ADDENDUM NO. 2

**RE: Scott County Extension Office
Renovation & Addition
1130 Cincinnati Road
Georgetown, Kentucky 40324**

**FROM: Brandstetter Carroll Inc.
2360 Chauvin Drive
Lexington, Kentucky 40517
Phone 859-268-1933
Fax 859-268-3341**

This Addendum forms a part of the Construction Documents dated November 9, 2023. Each Bidder shall acknowledge receipt of this Addendum in the space provided on the Bid Form. Failure to do so may subject the Bidder to disqualification.

**Furniture & Signage
Plans**

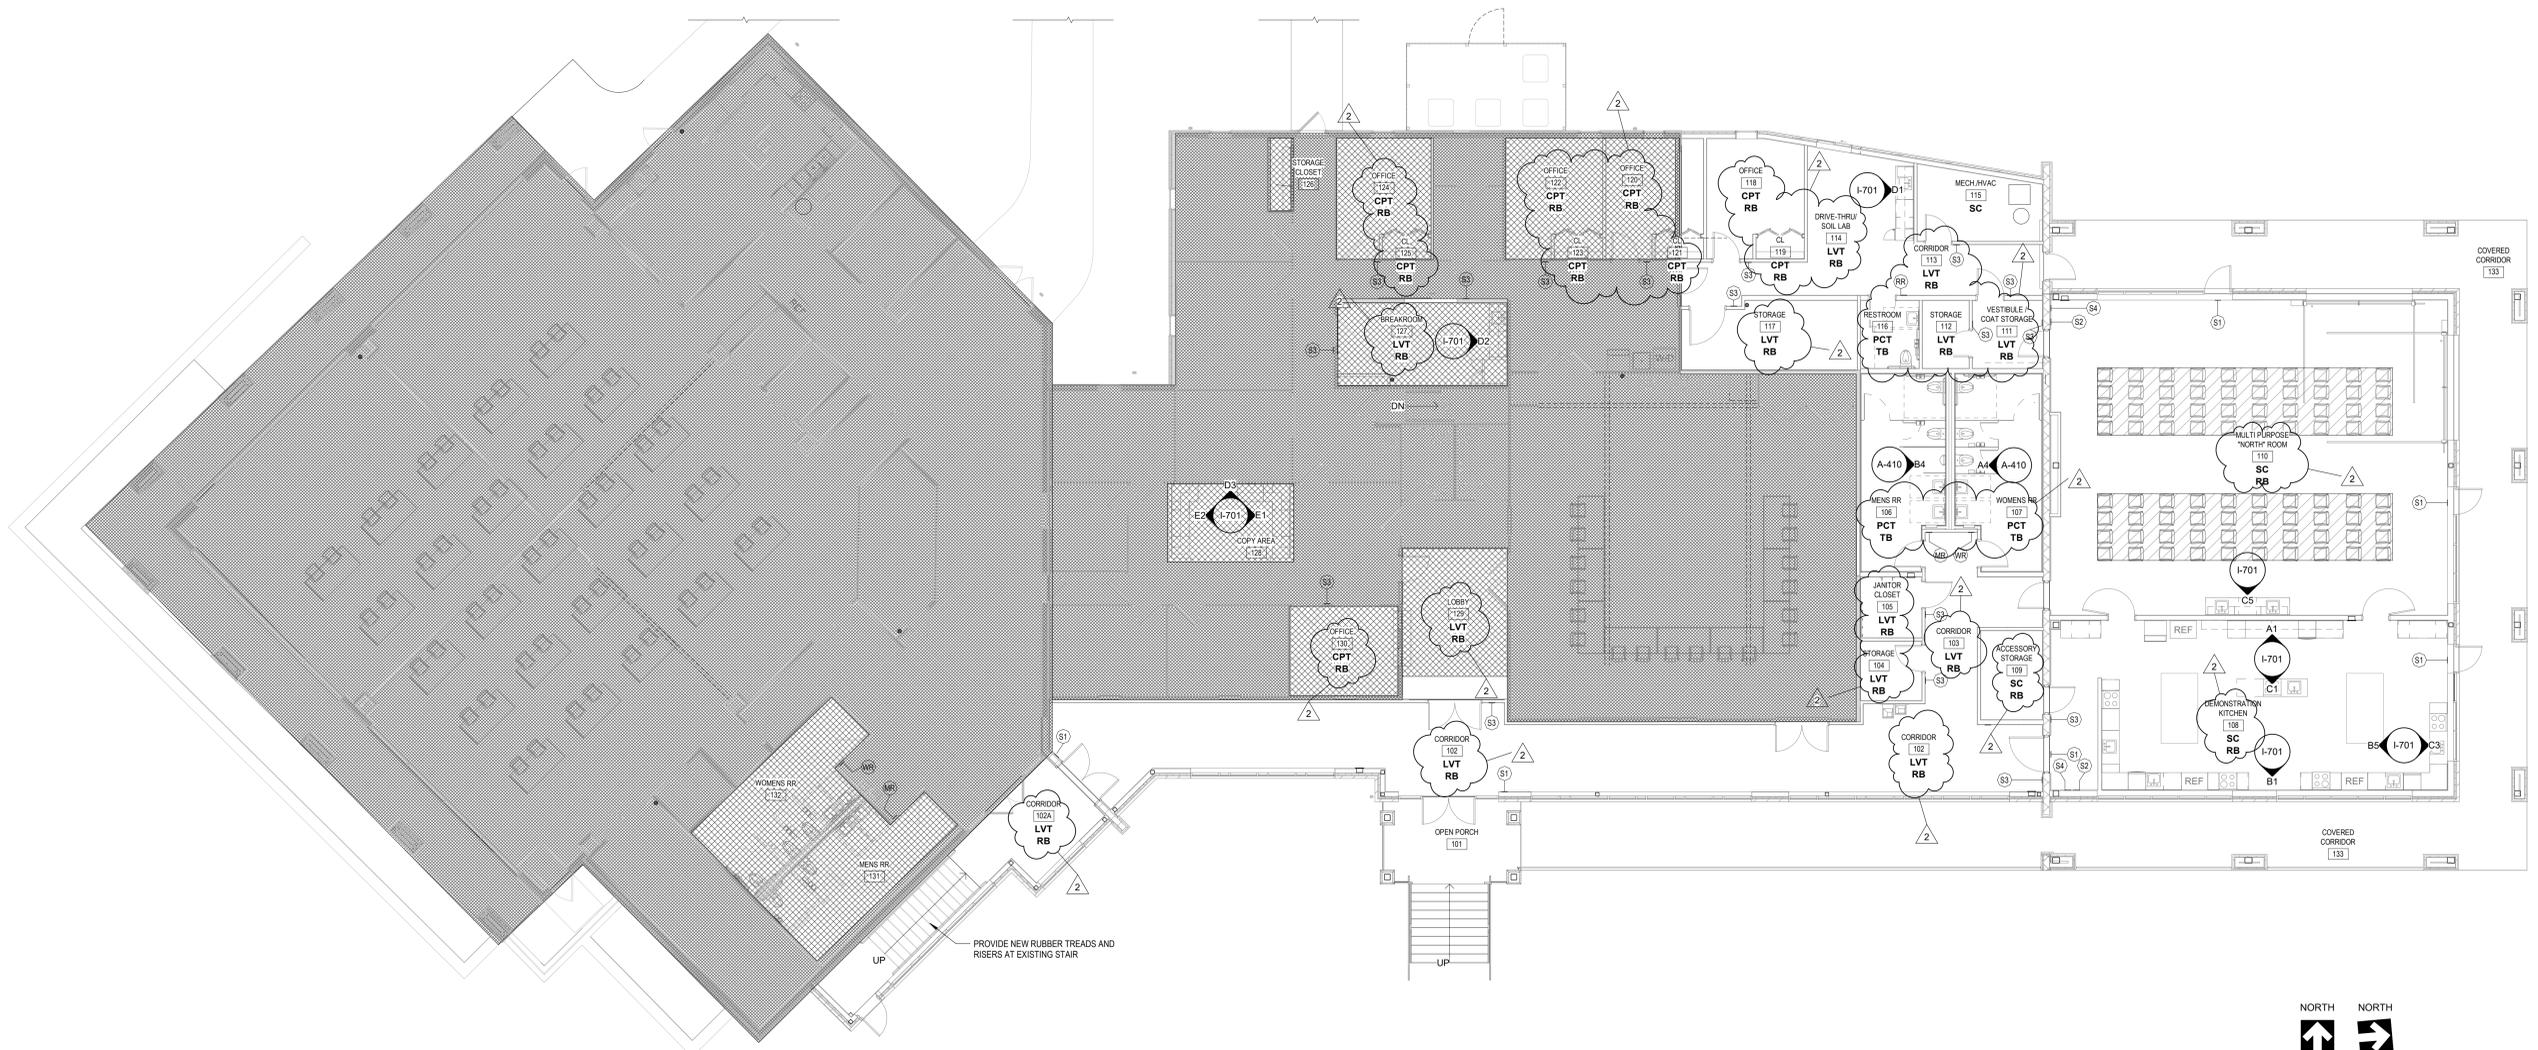
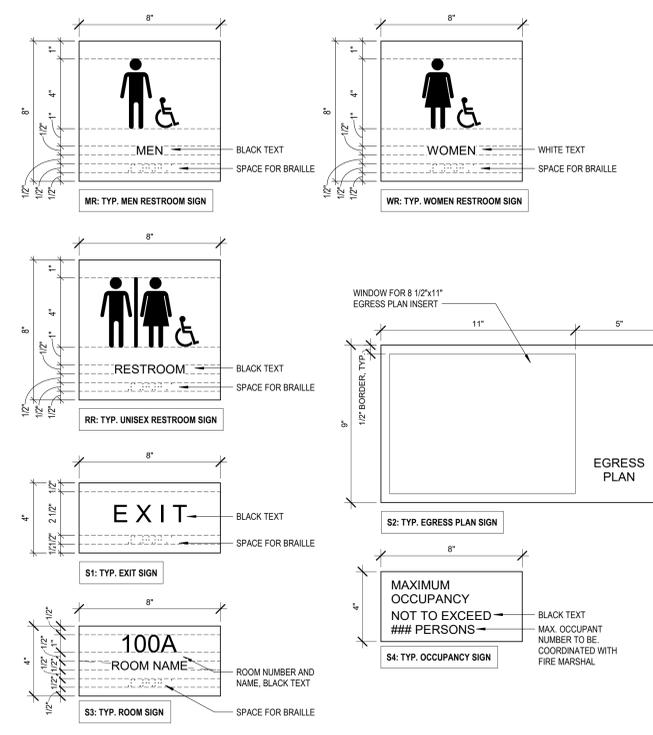
4. Can you please add a Room Finish Schedule to the plan set so we will know what the finishes are? Evidently this was left out. There is only one Interiors plan page and it pertains to casework. No architectural plan has the typical finish schedule either.

- a. Finishes are noted on sheet A-701 and have been updated. Refer to attached A-701.
5. There doesn't appear to be a finish schedule.
 - a. Refer to attached A-701.

18. Do we need to provide signage for the areas being renovated or just at the new construction areas?
 - a. Only as shown in sheet A-701.
19. Do we know what the existing keying/core system is?

1. Sheet A-120 Roof Plan: Removed detail reference B4/A-502 from the TPO roof area.
2. Sheet A-701 Furniture and Signage Plan: Update proposed finishes.

A1 Roof Plan - Renovation & Addition
1/8" = 1'-0"

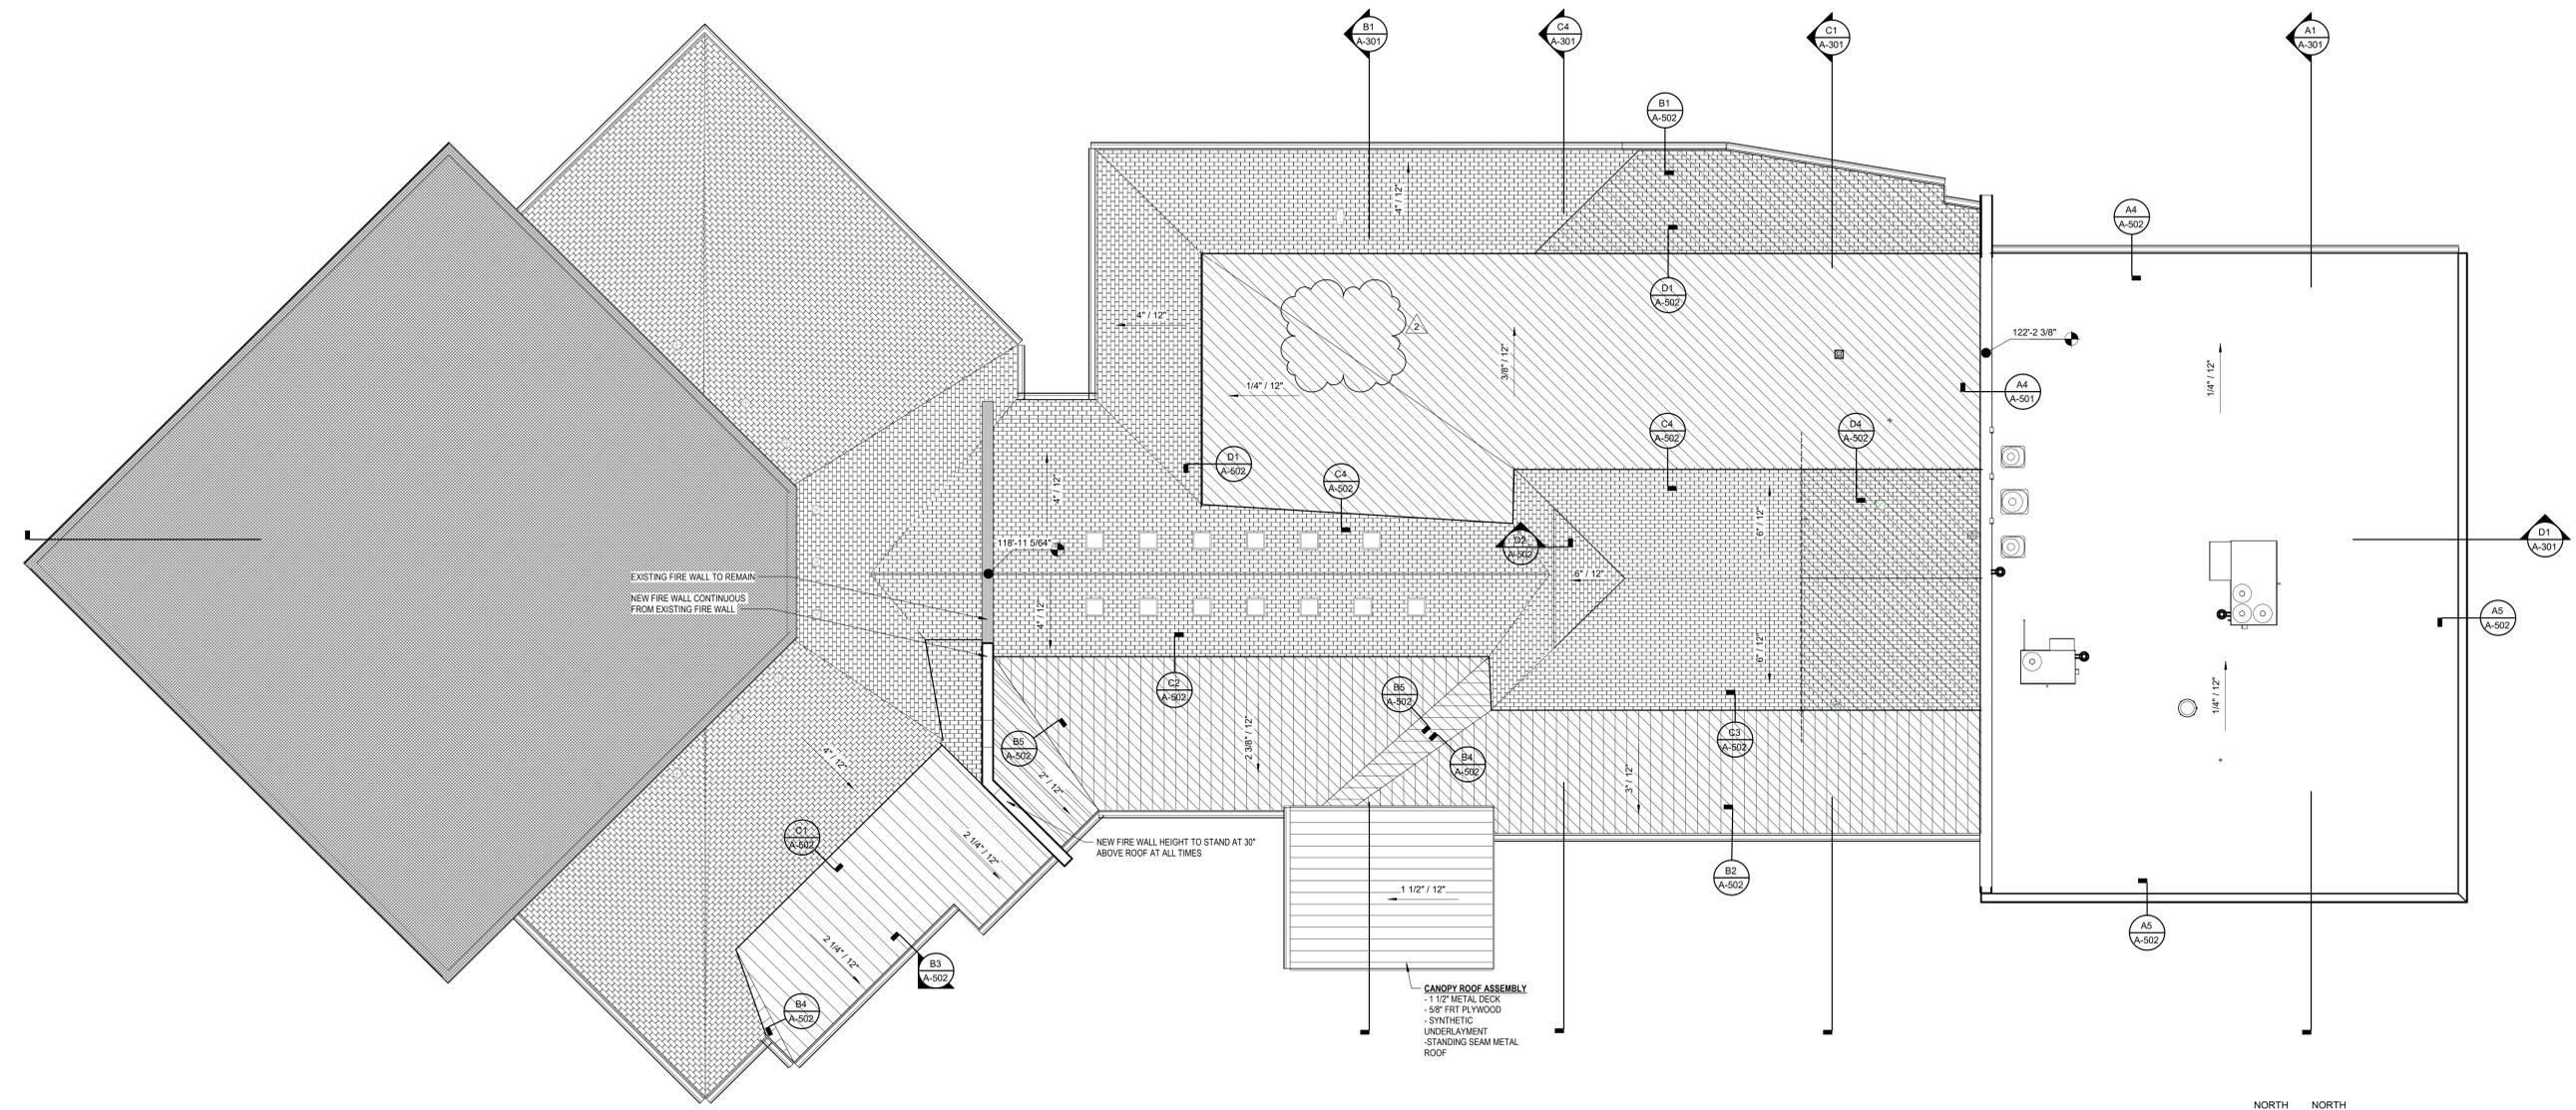
- a. No.
20. On the one TPO Membrane roof there is a cut detail B4/A-502 that takes you to a metal standing seam ridge vent detail and not a TPO one, wanted to see if this was an error and what the TPO membrane detail they are wanting to show there.

- a. This detail reference is incorrect and has been removed from the TPO roof area, refer to drawing A-120.
21. Wanted to confirm couple areas and roof assemblies. The existing EPDM roof on the south face (tallest existing roof) this is the only roof to remain, correct all other roofs will be removed and new system put on. Also, with Shingle Roof Assembly 02- they don't actually list out assembly as they do for all the assemblies. Do you know of the assembly in those areas? Do they have the 5" of ISO there as well?
